**AGENDA
FARRAGUT MUNICIPAL PLANNING COMMISSION**

**November 15, 2018
7:00 p.m. Farragut Town Hall**

Re: Staff comments on site plan for Way Station Road Extension

**RE: Cath Lab, OB, CCU, and Connector Addition and Renovation at Tennova Turkey Creek Medical Center—Site Plan Review Comments Response
Knoxville, TN**

Preliminary Plat - Tree Preservation and Removal Plan
Ivey Farms Road
12639 Kingston Pike
Farragut, Tennessee 37934
Clayton Properties Group, Inc.

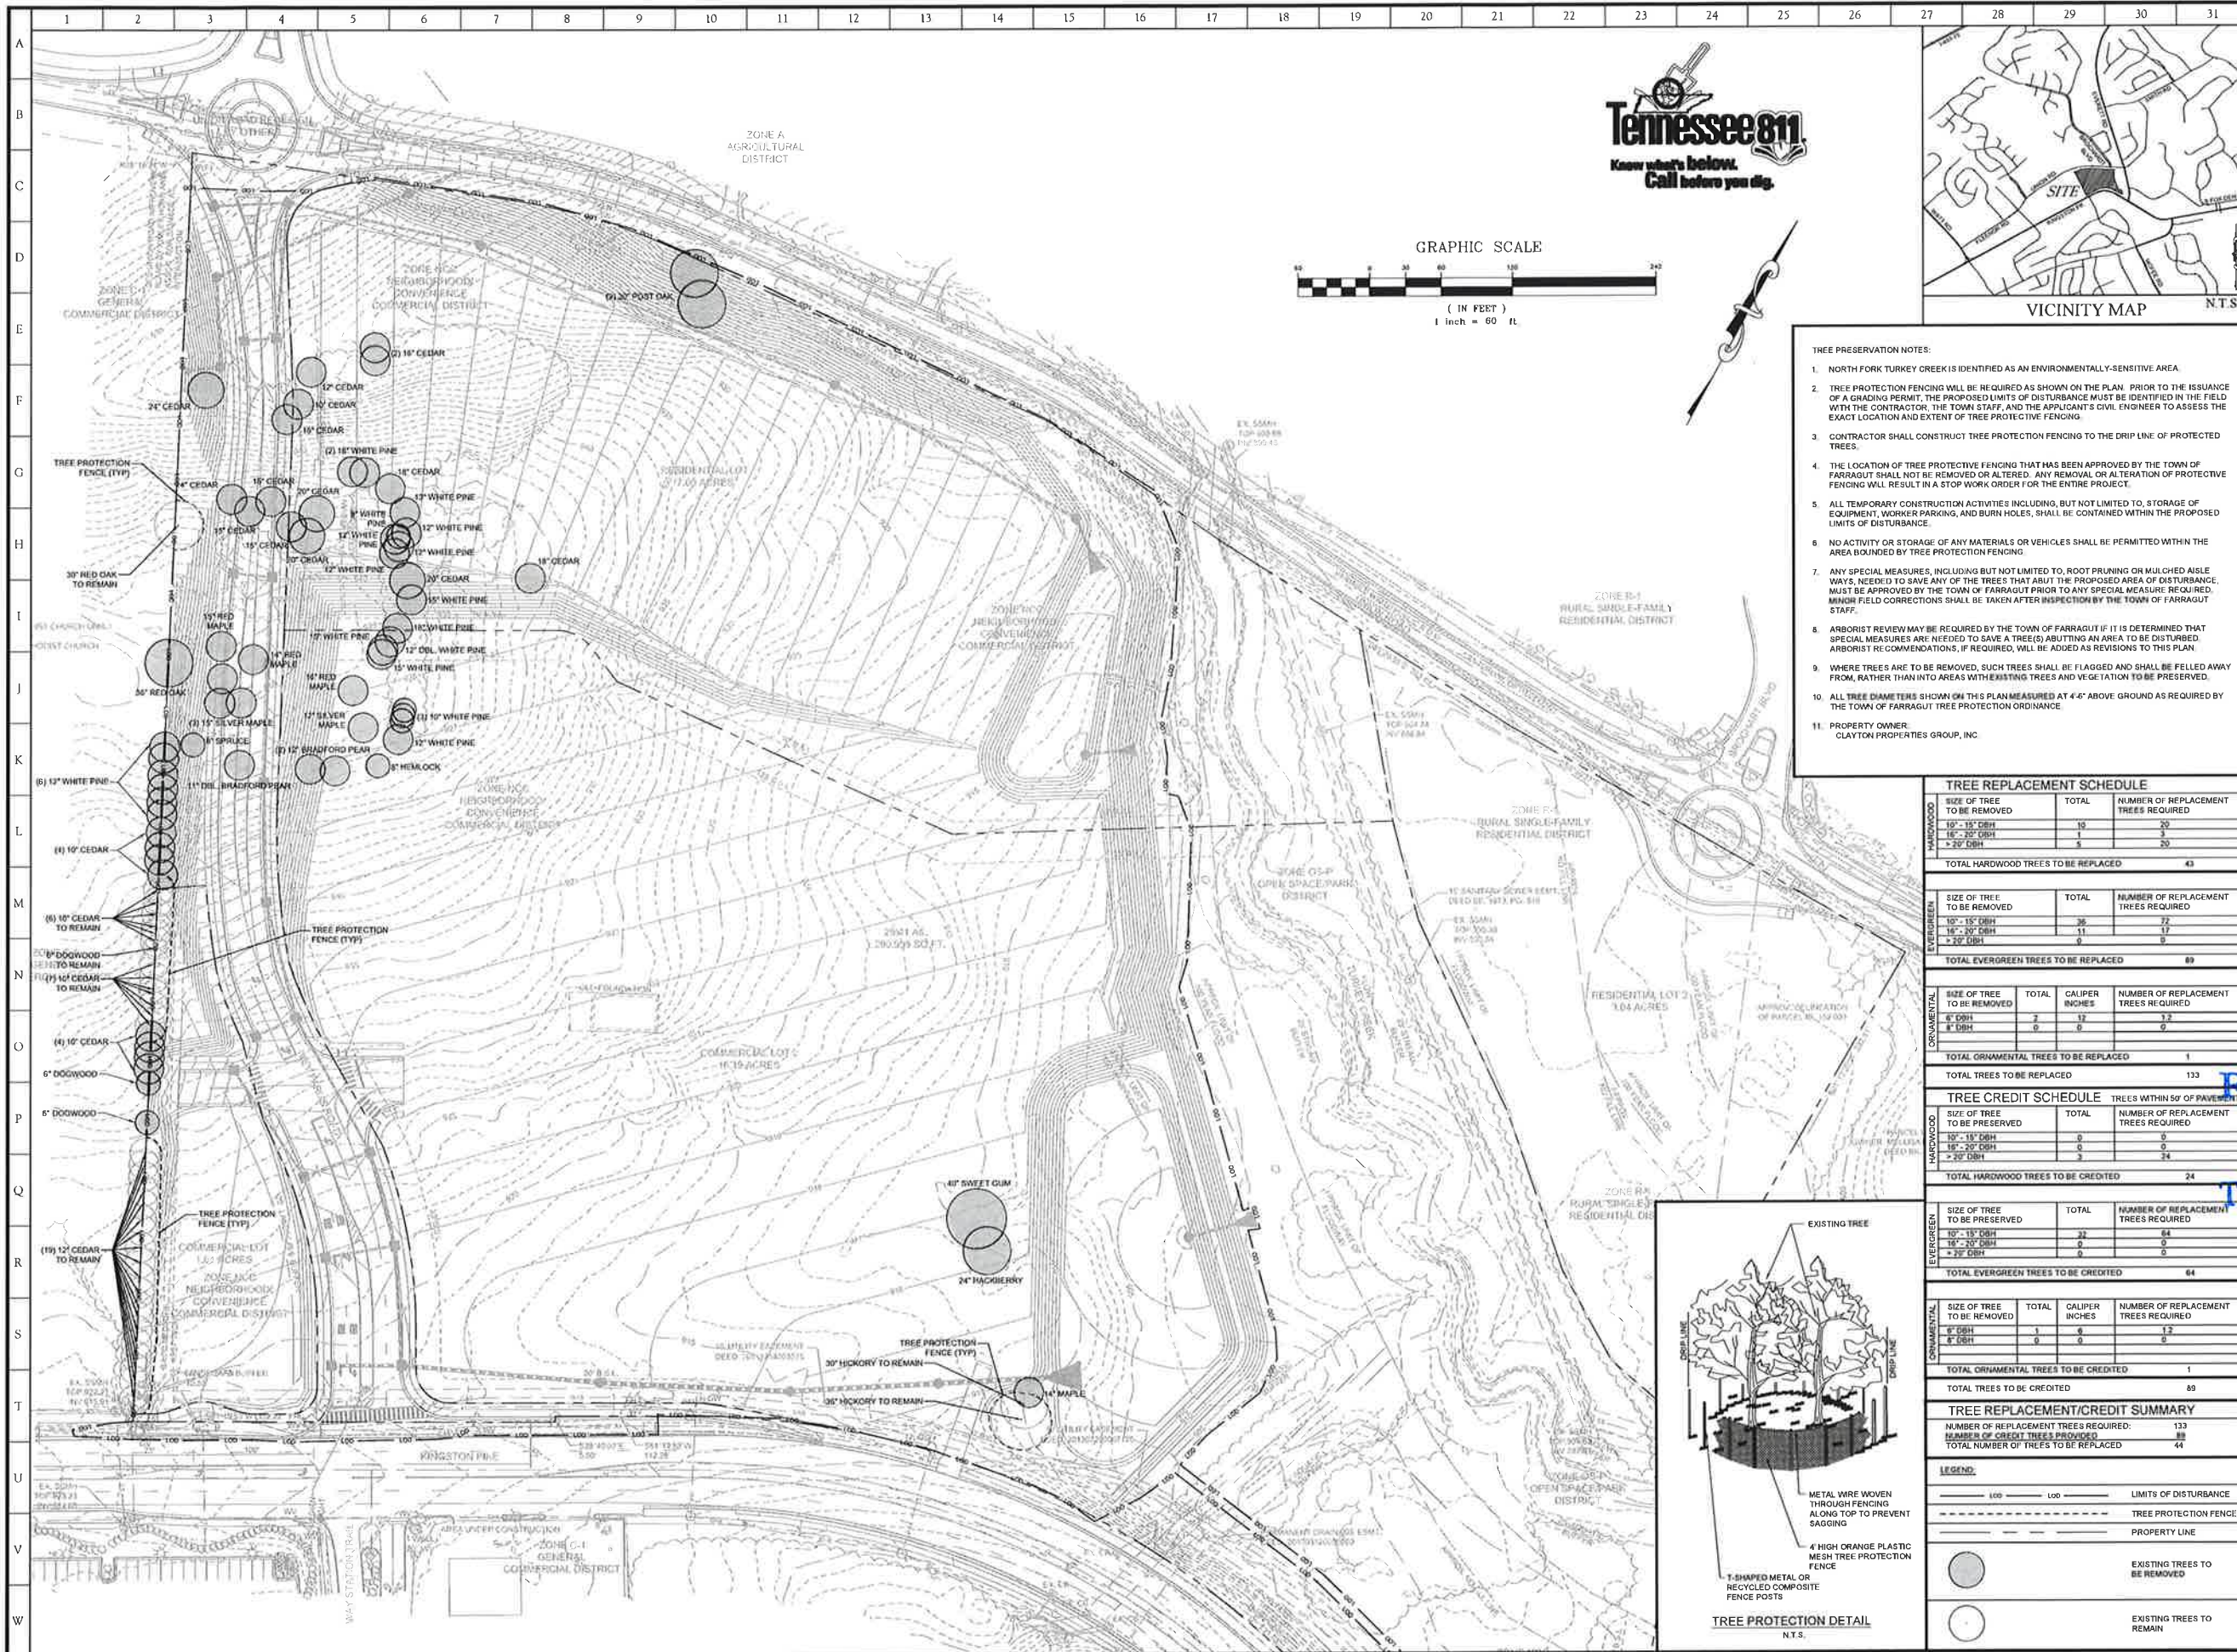
- 7) The tree preservation/removal plan must be prepared by a landscape professional as provided for in the Tree Protection Ordinance. An arborist review will be needed for selected trees where special measures may need to be employed to save such trees; **The incorrect seal was replaced, Arborist review is note #8 on the plan.**

C3.0
SHEET 0 OF 9

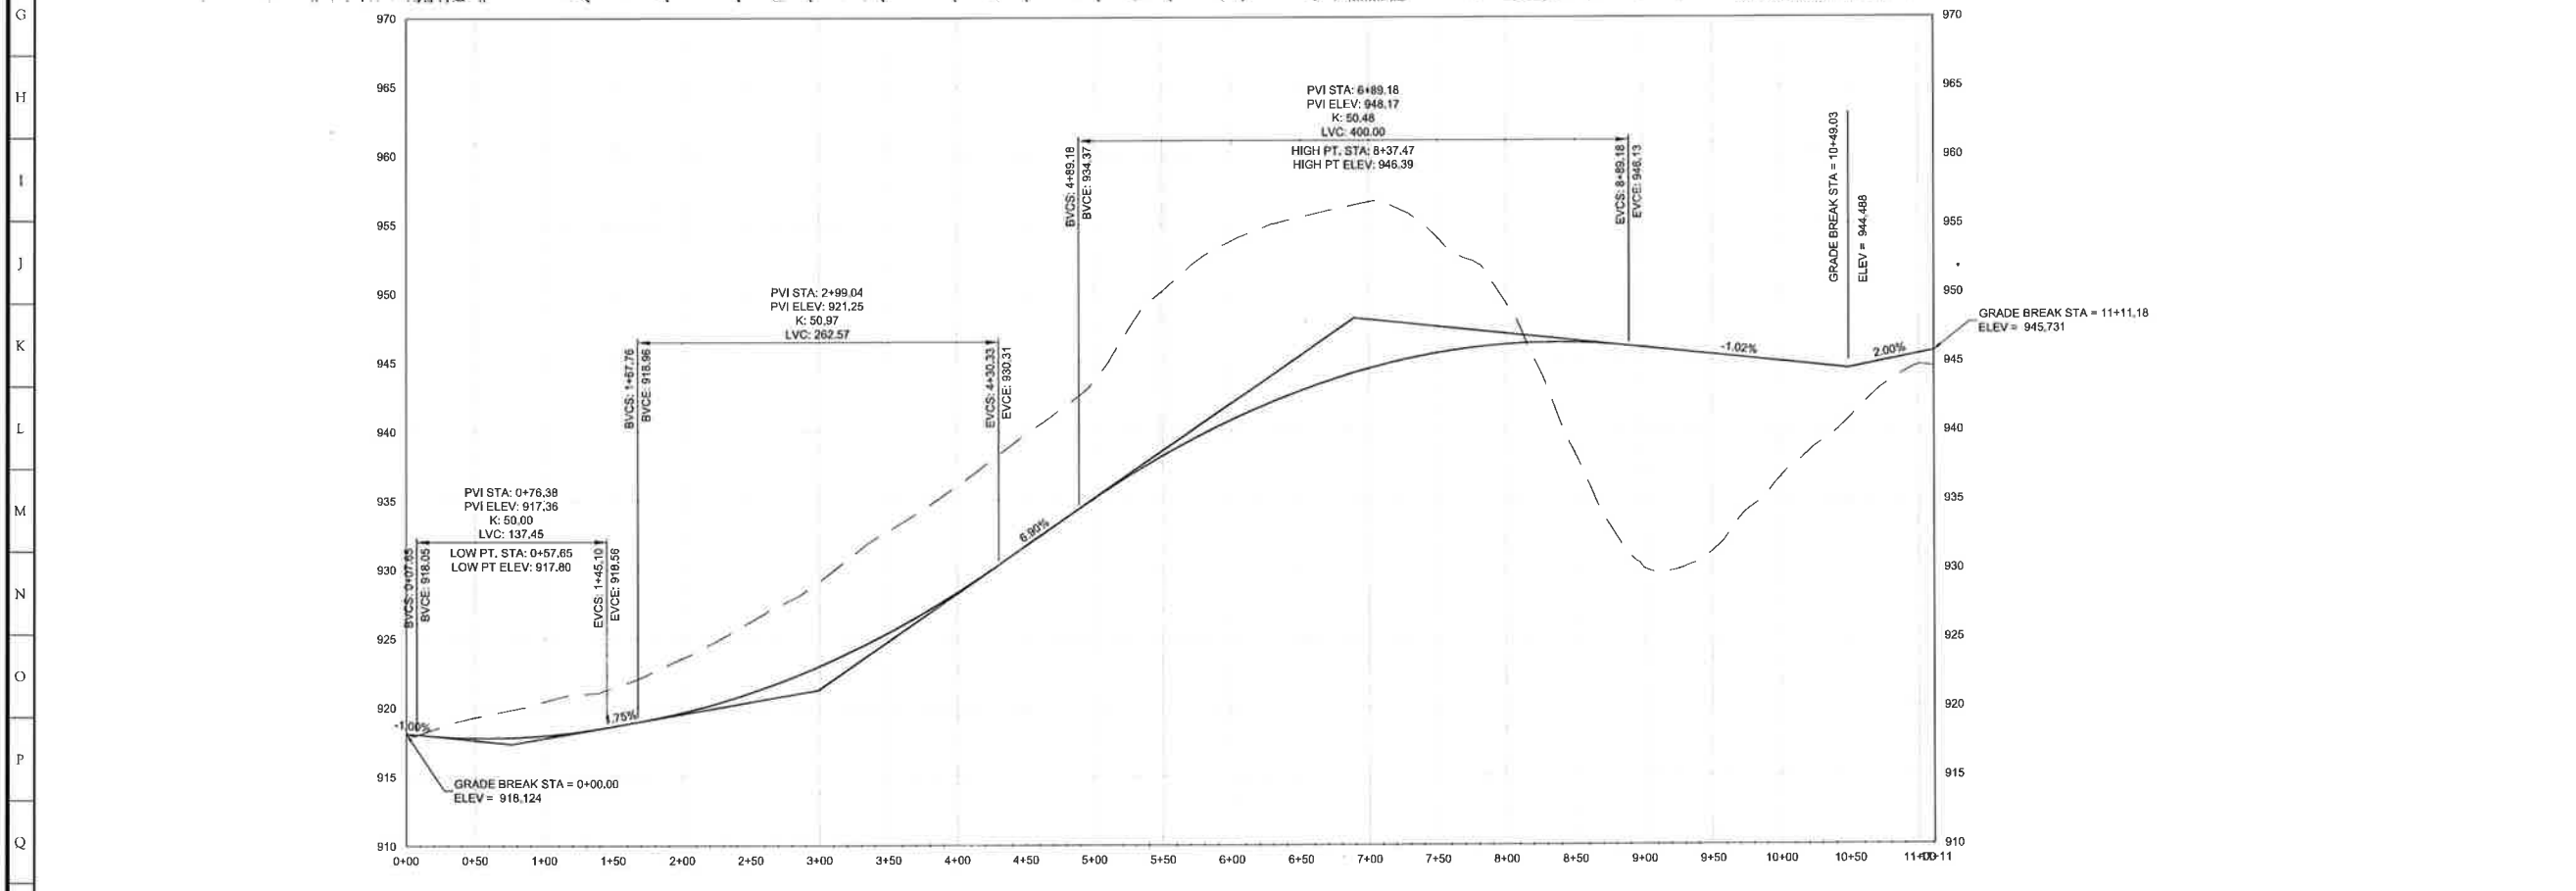
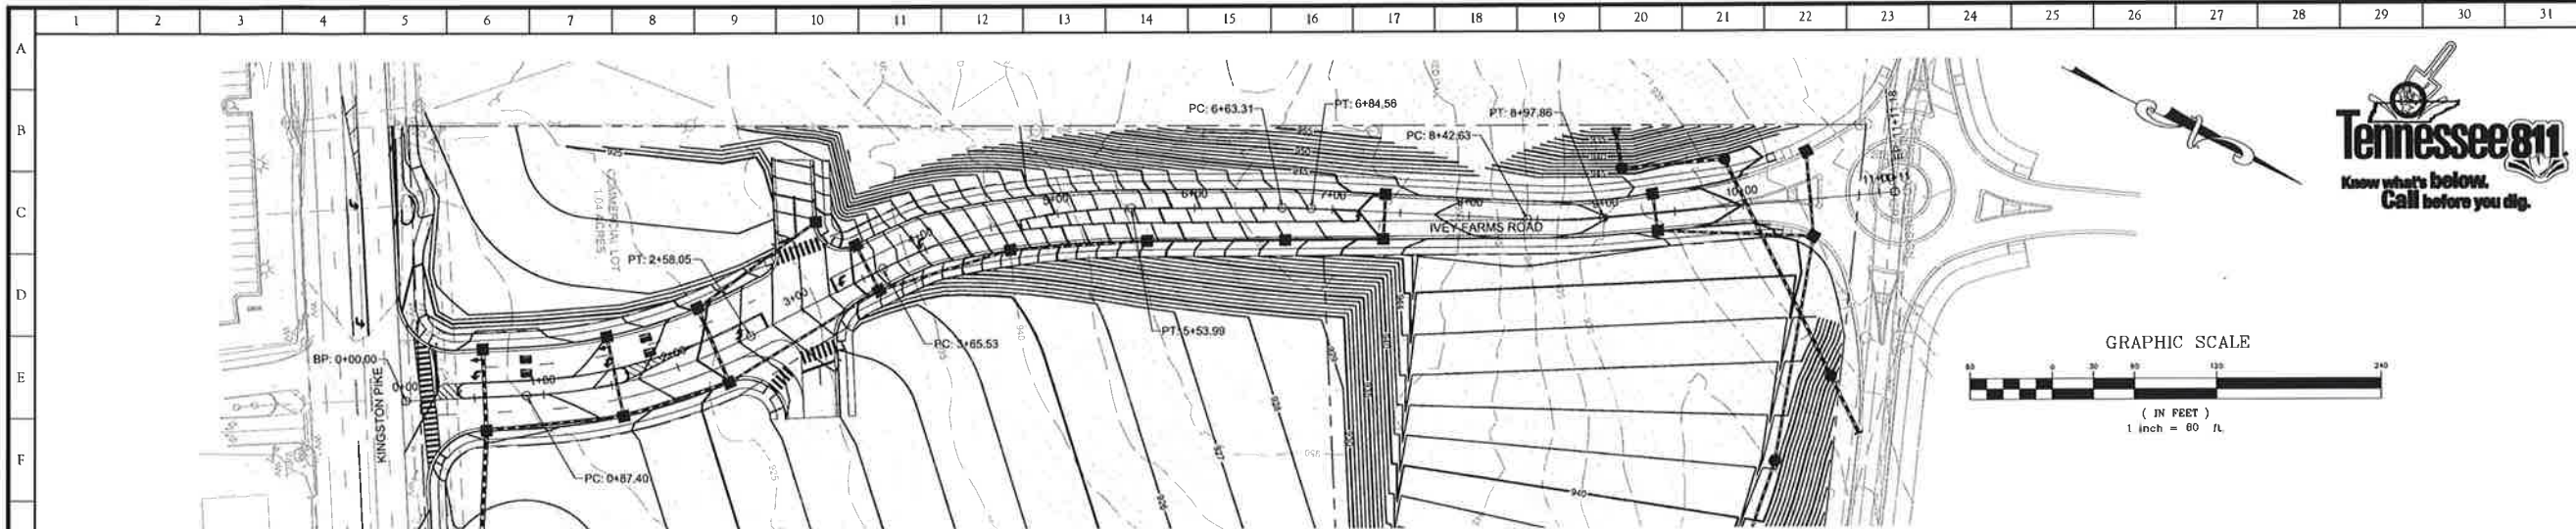
- 19) A "no fill" line should be added to the east side of Turkey Creek; **Lines on east side of creek have been added.**
- 20) Please add required Minimum Floor Elevation note; **MFE note has been added to C3.0**

A401

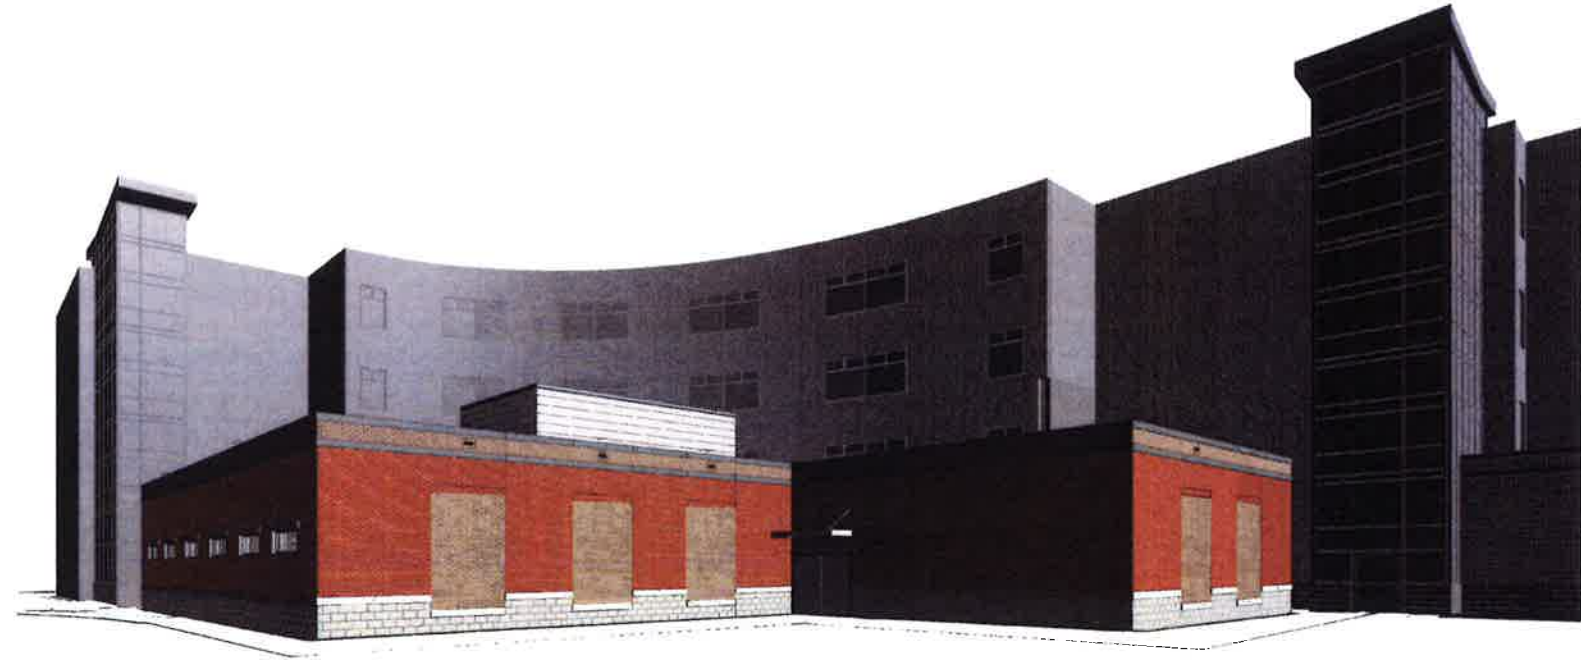
10. Please include color renderings of the building façade and proposed modifications to assure compliance with Architectural Design Standards. Materials and color samples will be needed for the Planning Commission meeting on November 15.

Revised color renderings can be found on sheet A400, A401, & A402. Per conversation with Mark Shipley the material samples can be omitted in lieu of color renderings due to matching adjacent existing colors and materials.
